**RALEIGH SUBDIVISION, UNIT THREE,**  
**RESUBDIVISION OF LOTS 2 & 3**

APPLICATION NUMBER 13 DATE June 21, 2007

# DETAIL SITE PLAN

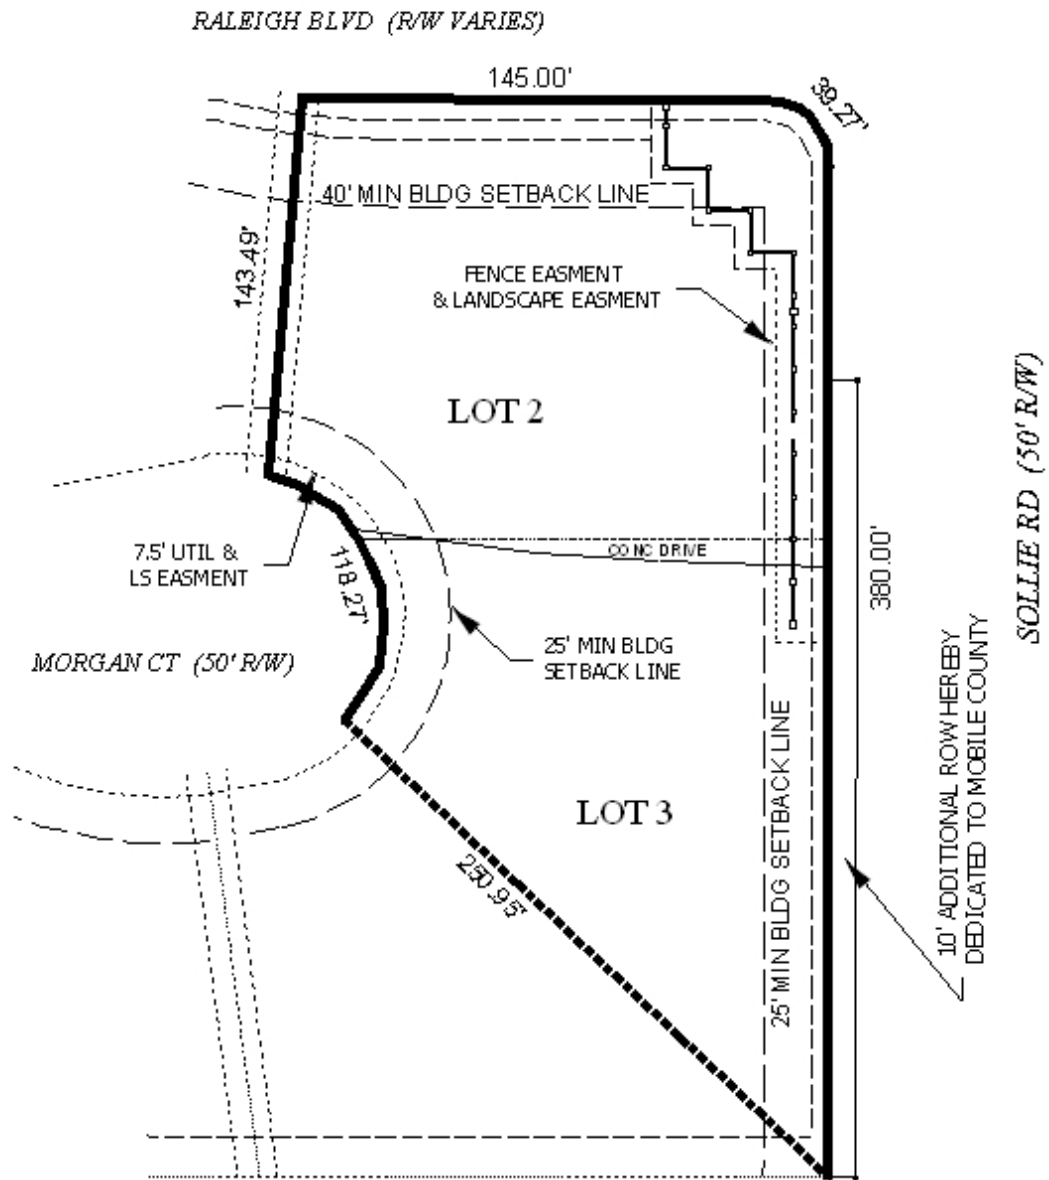
Both of the proposed lots front Morgan Court, and the proposed Lot 1 also fronts Raleigh Boulevard and Sollie Road. The original approval granted in 2001 stated that there should be no access to Sollie Road. The appears to be no reason why this stipulation should not be included in this resubdivision. Therefore, a note should be required on the final plat stating that both of the proposed Lots 2 and 3 should be denied access to Sollie Road.

The plat additionally illustrates a proposed 10-foot dedication along Sollie Road. This should not be required as the original approval creating these lots in 2001 required dedication sufficient to provide 50-feet from the centerline of Sollie Road, therefore, this dedication should be removed, and the current right-of-way of Sollie Road depicted.

All of the required setbacks are indicated on the plat, and there should be no modifications necessary. Additionally, both lots exceed the minimum required lot size under the subdivision regulations.

- 3) a note should be placed on the final plat stating that both Lot 2 and Lot 3 are denied access to Sollie Road;
- 4) deletion of the proposed right-of-way dedication;

- 5) depiction of the current right-of-way of Sollie Road; and
- 6) provision of the seven copies of the recorded plat of Raleigh Addition Subdivision from 2001.
